06-324r7 SAS-2 Modifications to the SAS Speed Negotiation

To: T10 Technical Committee
From: Amr Wassal, PMC-Sierra (amr_wassal@pmc-sierra.com)
Stephen Finch, STMicroelectronics (steve.finch@st.com)
Date: 20 September 2006
Subject: 06-324r7 SAS-2 Modifications to the SAS Speed Negotiation

Figure 122 — SAS SNW-1, SNW-2 and Final-SNW

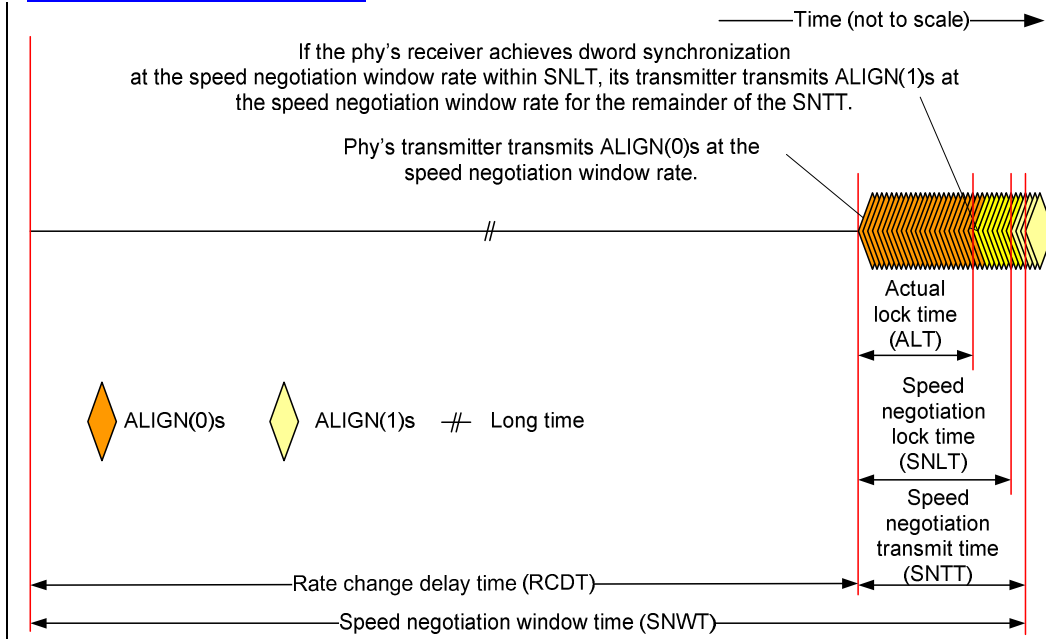
Figure 122 defines the SAS speed negotiation window format for SNW-1, SNW-2 and Final-SNW, including:

Figure 122 updated in Rev 7.

The speed negotiation window shall consist of the following transmission sequence:

- 1) transmission of D.C. idle for an RCDT; and

- 2) if the phy supports the physical link rate or if this is the Final-SNW, transmission of ALIGNs at the physical link rate specified below for the remainder of the entire speed negotiation window time. If the phy does not support the physical link rate, transmission of D.C. idle for the remainder of the entire speed negotiation window time.

Figure 123 — SAS SNW-3

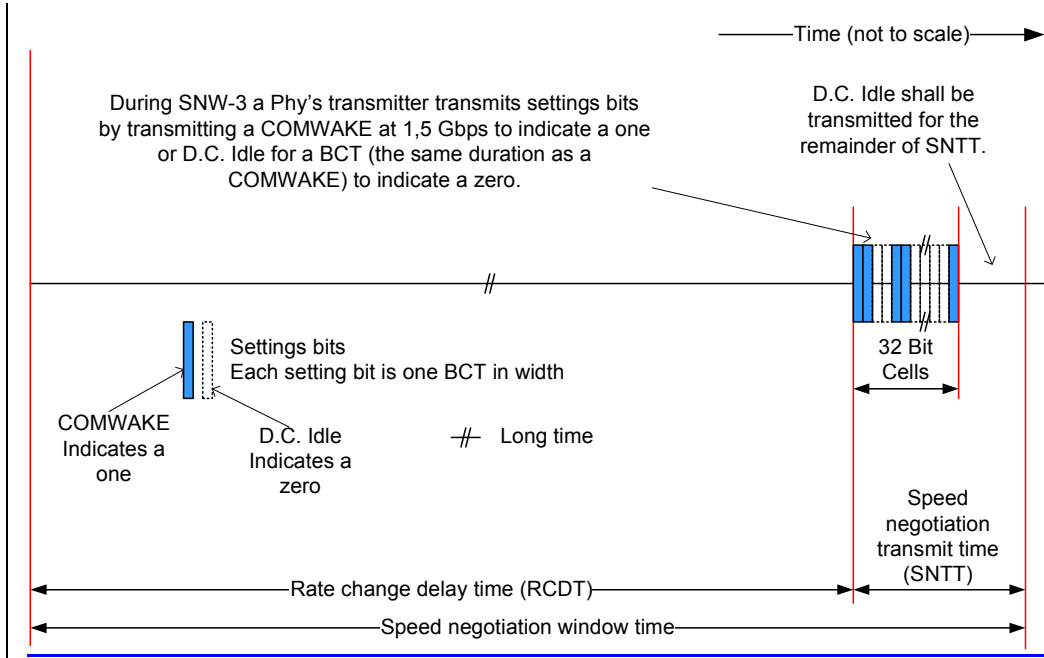
[Figure 123](#) defines the SAS SNW-3, including:

Figure 123 updated in Rev 7.

The first bit of information is the start bit and shall be transmitted as a one. Each of the remaining 31 bits of information may be a one or a zero. The transmitter shall transmit 32 BCTs (see Table 80) after an RCDT and then transmit D.C. Idle for the remainder of SNTT.

Each BCT consists of the transmission of a COMWAKE signal (see 6.6.2) or the transmission of D.C. Idle. To transmit a one, a COMWAKE shall be transmitted in the BCT. To transmit a zero, a D.C. Idle shall be transmitted in the BCT.

Figure 124 — SAS Train-SNW

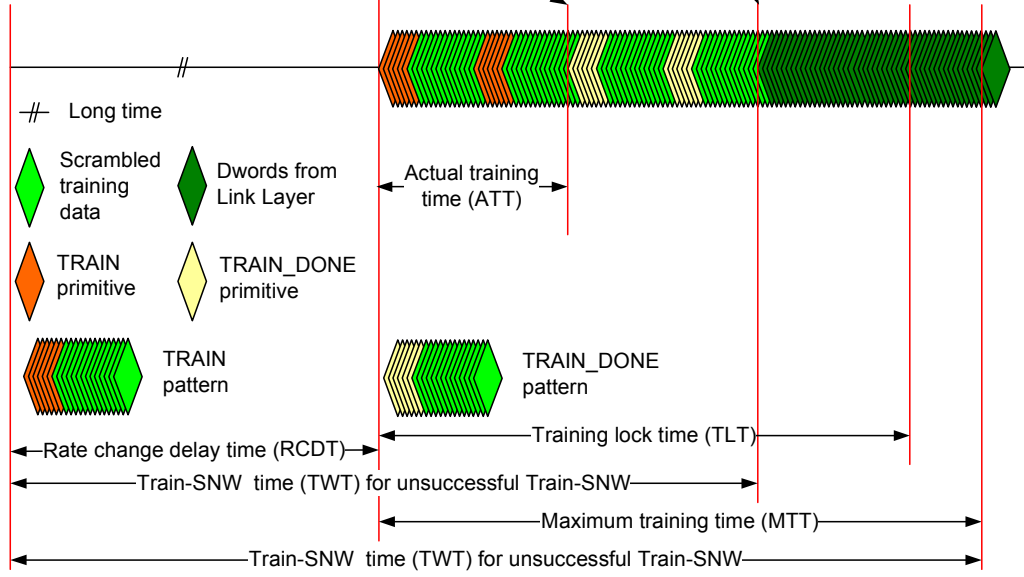
Figure 124 defines the Train-SNW, including:

Figure 124 updated in Rev 7.

The phy shall transition to transmitting Link Layer dwords after transmitting a minimum of 4 TRAIN_DONE patterns and receiving one TRAIN_DONE. This represents the successful end of the Train-SNW and the beginning of normal link layer operation. If a phy has not transmitted at least four TRAIN_DONE patterns, and receive at least one TRAIN_DONE within MTT, then the Train-SNW is unsuccessful.

Actual training time (ATT) starts after RCDT and ends when receiver training is completed and dword synchronization is obtained. The phy transmits the TRAIN pattern starting after RCDT. A minimum of one TRAIN pattern shall be transmitted. When ATT ends, the phy transitions to transmitting TRAIN_DONE patterns. If ATT does not end before TLT, then the phy shall not transition to transmitting the TRAIN_DONE pattern.

Figure 125 — SAS speed negotiation sequence (phy A: G1, G2, G3, phy B: G2 only)

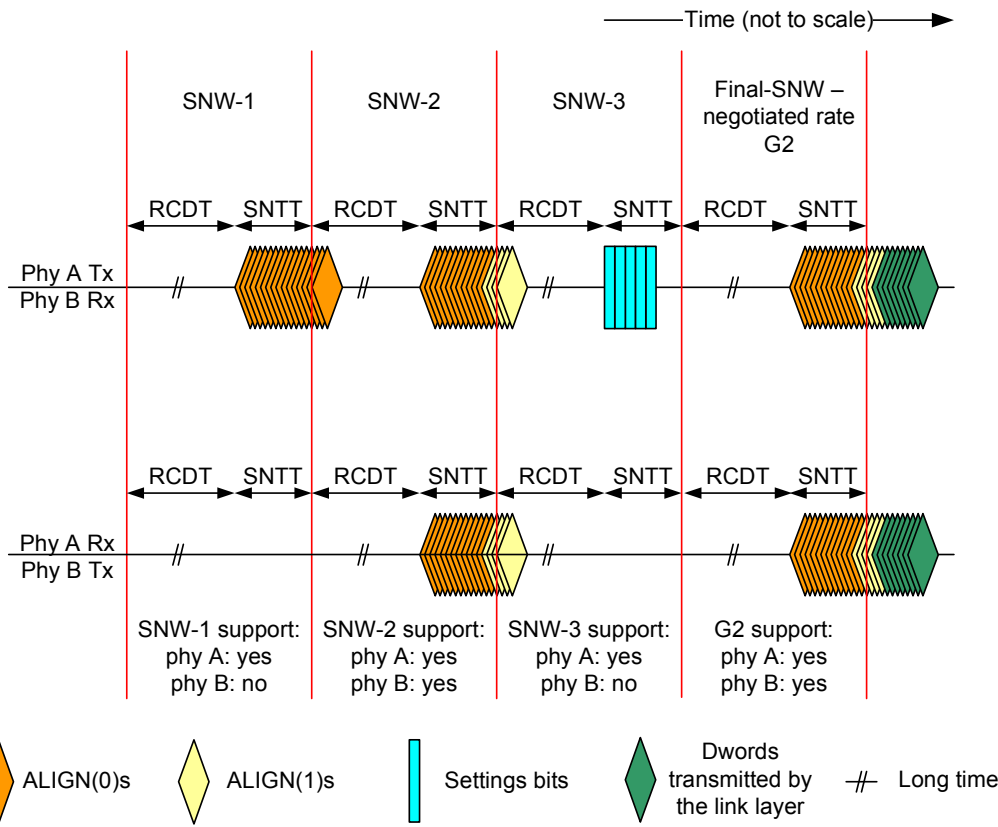
Figure 125 is an example of speed negotiation between a phy A that supports G1 through G3 and a phy B that only supports G2. Both phys participate in:

Figure 125 updated in Rev 7.

Phy A and phy B detect an invalid SNW-1, a valid SNW-2, followed by an invalid SNW-3, and correctly proceeds to a Final-SNW at G2.

Figure 126 — SAS Final-SNW phy reset problem

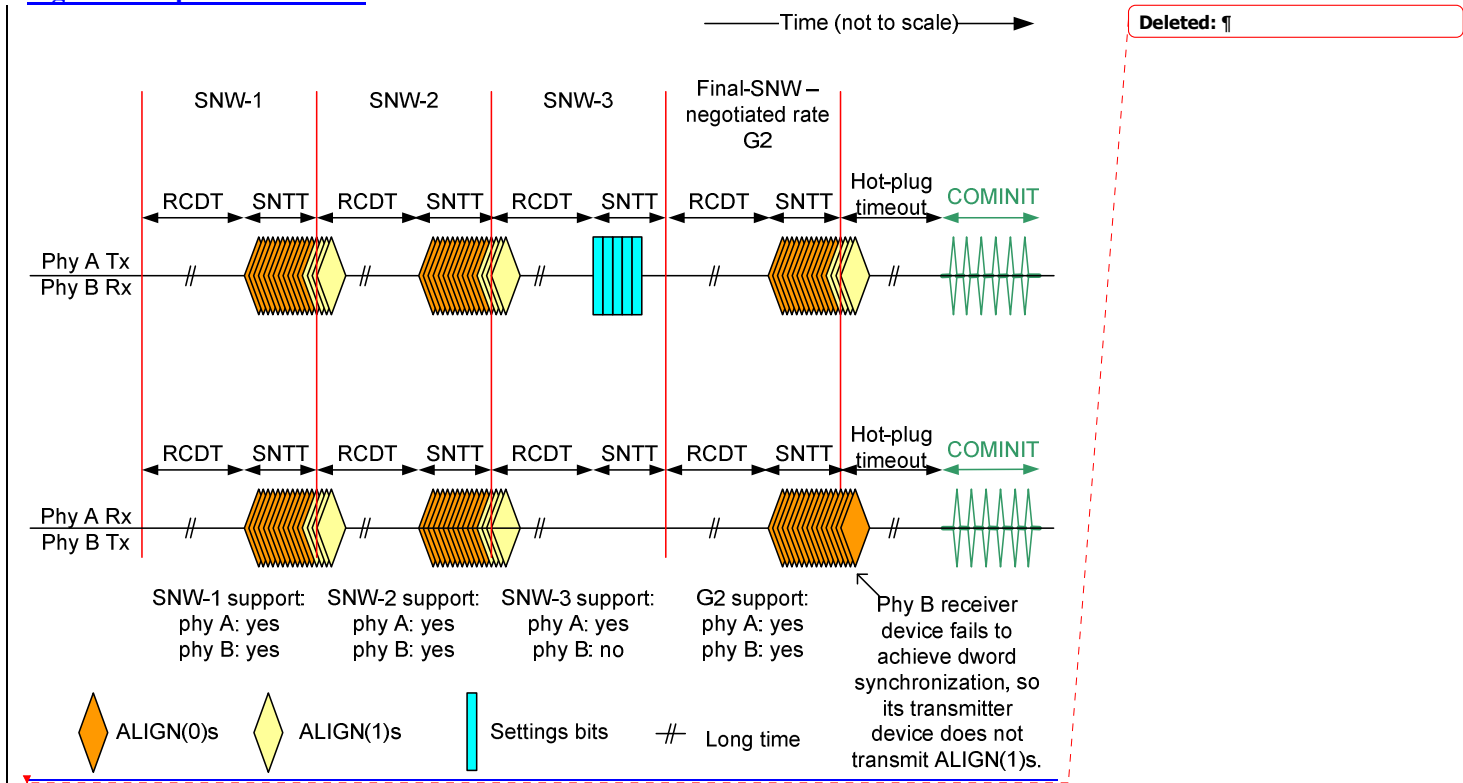
Figure 126 shows a speed negotiation sequence where phy B does not achieve dword synchronization during the Final-SNW. If this occurs, the handshake is not complete and the phy reset sequence is retried.

Figure 126 updated in Rev 7.

Figure 127 — SAS speed negotiation sequence (phy A: G1, G2, G3 or higher, phy B: G1, G2, G3 or higher)

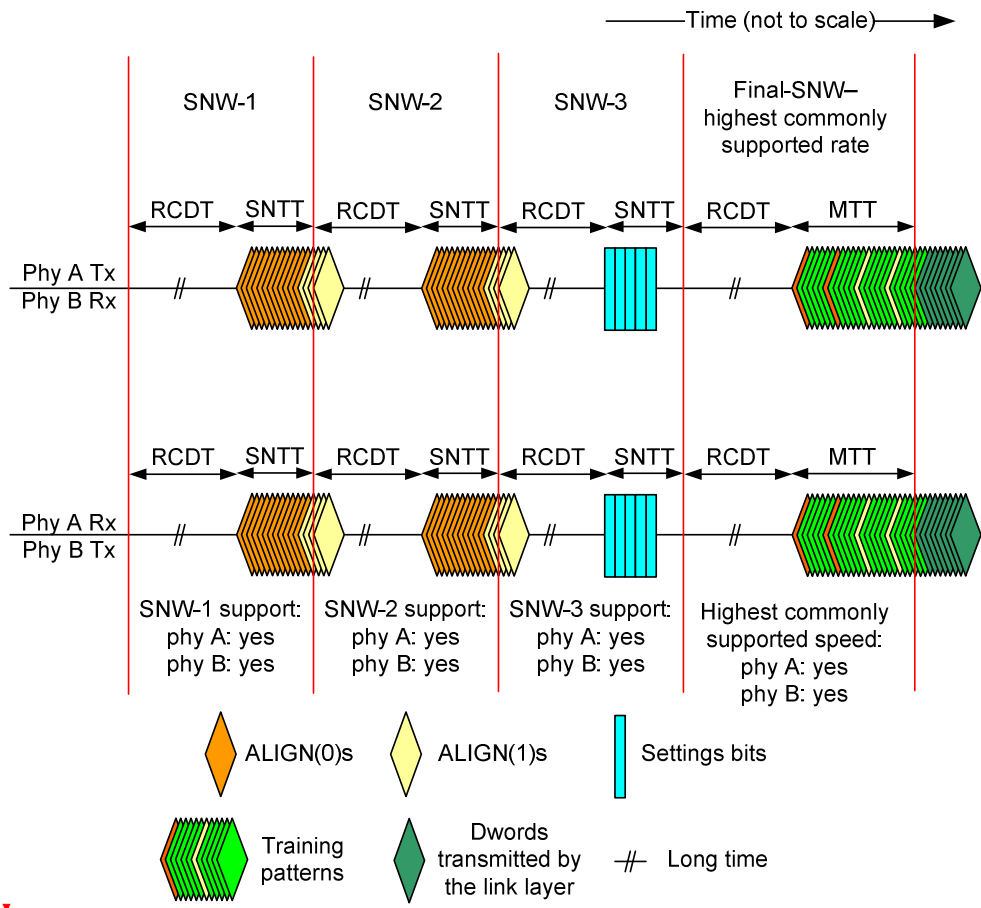
Figure 127 shows speed negotiation between a phy A and a phy B that both support G1 and G2 rates without requiring training and also support additional capabilities. Both phys participate in:

Figure 127 updated in Rev 7.

Figure 128 — SAS speed negotiation sequence - SNW-3 (maximum SNW) phy reset problem

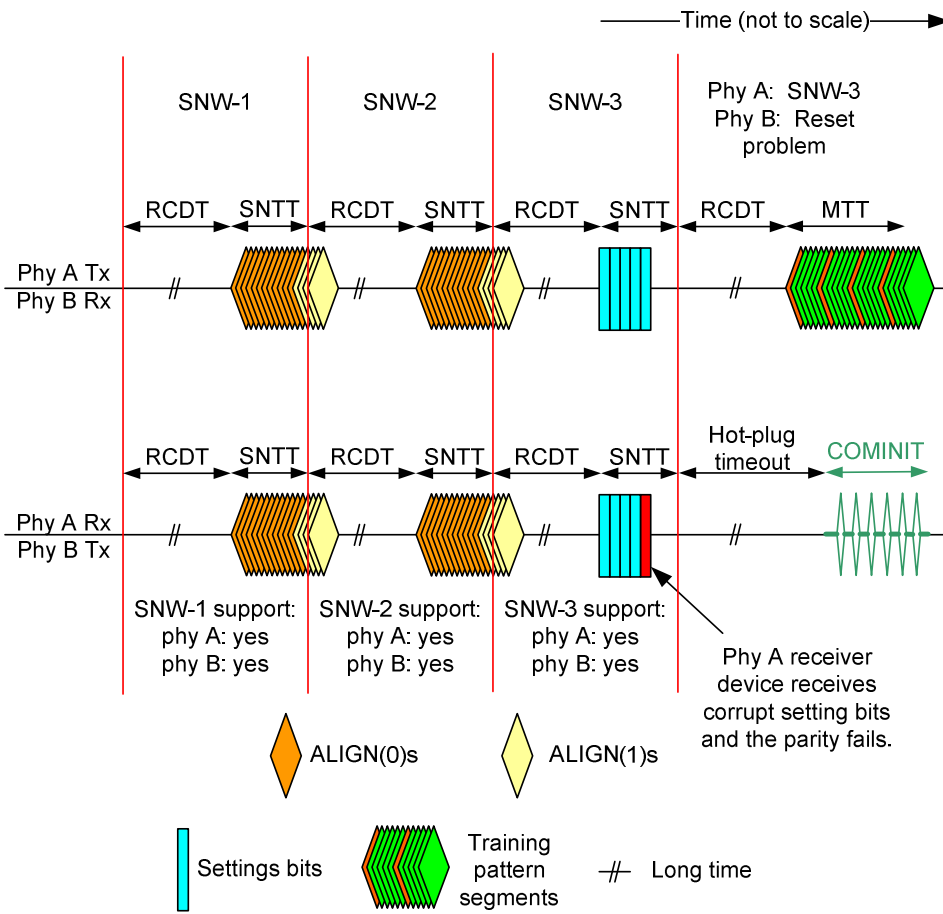
Figure 128 updated in Rev 7.

Figure 129 — SAS speed negotiation sequence - training (Train-SNW) phy reset problem

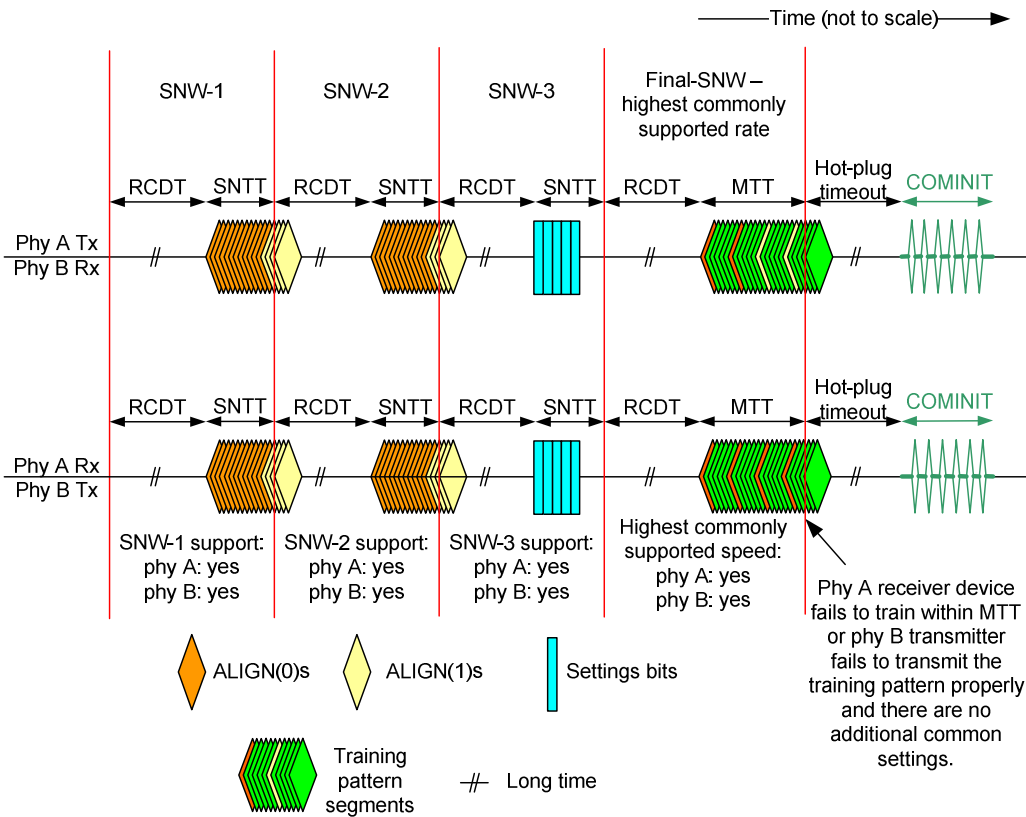
Figure 129 updated in Rev 7.

Figure NEW1 – SAS speed negotiation sequence – First Train-SNW is invalid, Second Train-SNW valid

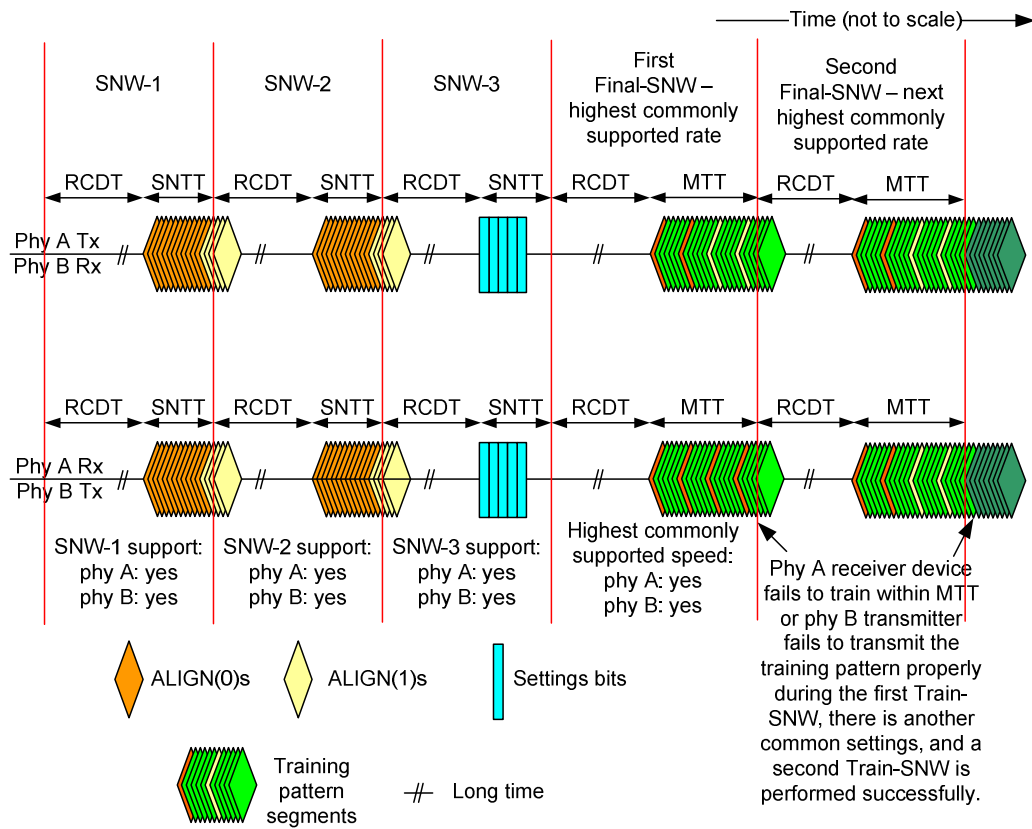
If settings bits are exchanged that contain more than one common setting and the Train-SNW using the highest common capability is invalid, a second Train-SNW is performed using the next highest common setting, as shown in Figure NEW-1.

Figure 131— SP (phy layer) state machine - SAS speed negotiation states

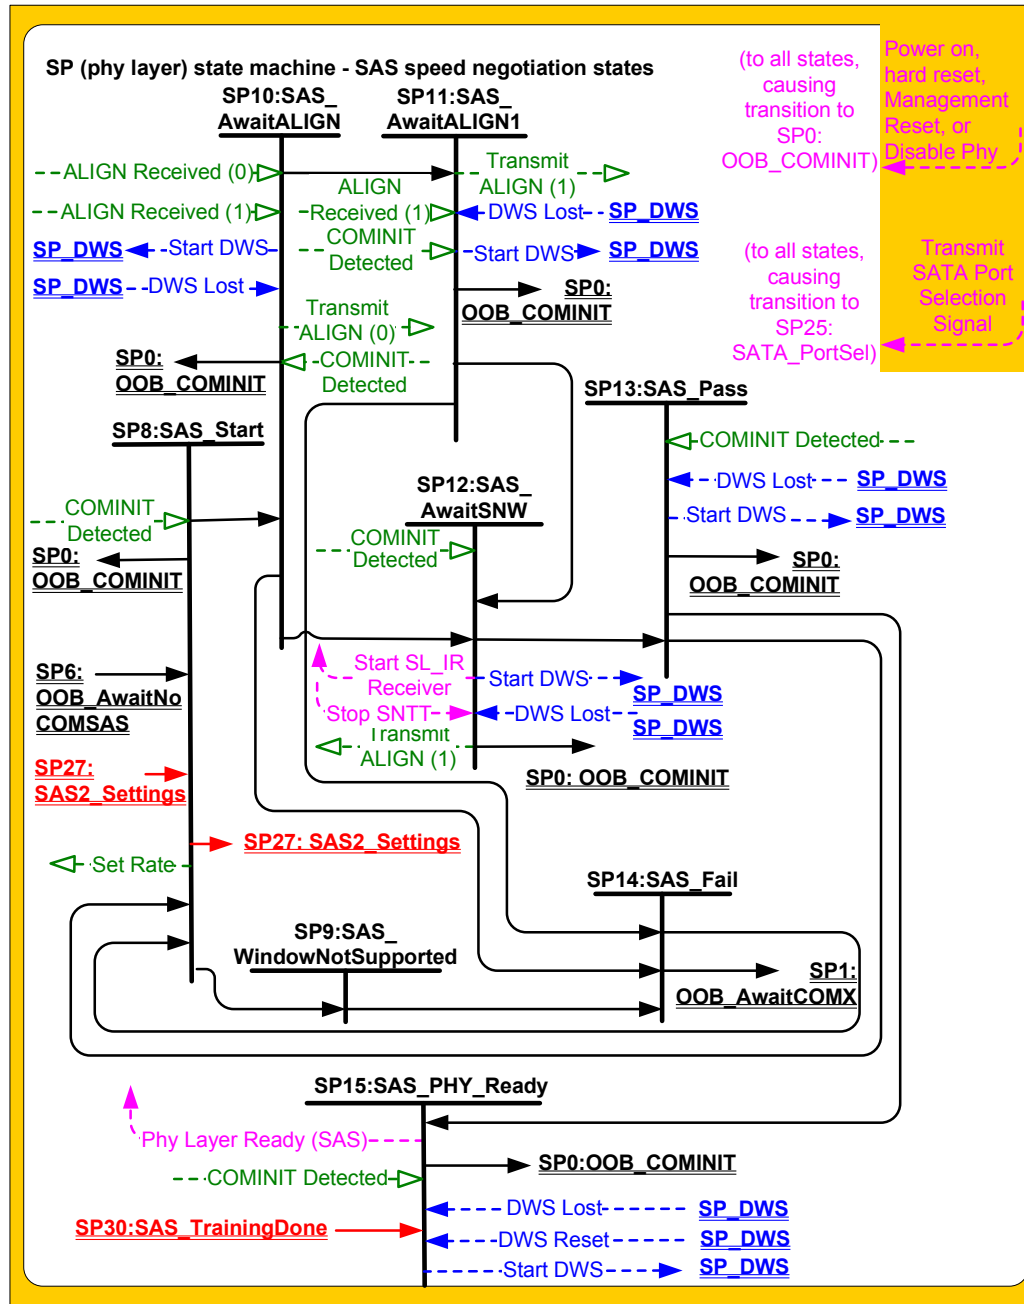
Figure 131 shows the SAS speed negotiation states, in which the phy has detected that it is attached to a SAS phy or expander phy rather than a SATA phy, and performs the SAS speed negotiation sequence. These states are indicated by state names with a prefix of SAS.

Changes to Figure 132 are in RED and Underlined in the figure. The associated transition arrows are also added in RED.

Figure 132 — SP (phy layer) state machine - SAS speed negotiation states (continued)

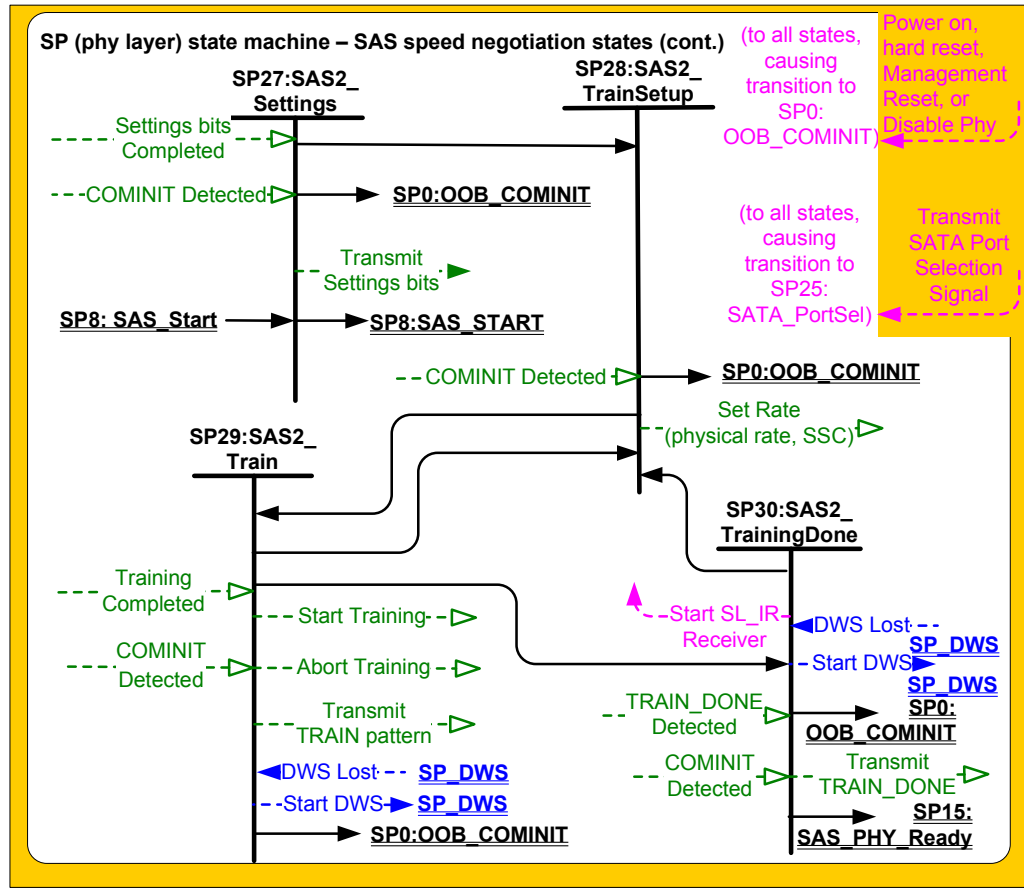
Figure 132 is a completely new figure.

Figure 132 shows the rest of the SAS speed negotiation states related to SNW-3 and the Final-SNW speed negotiation windows.
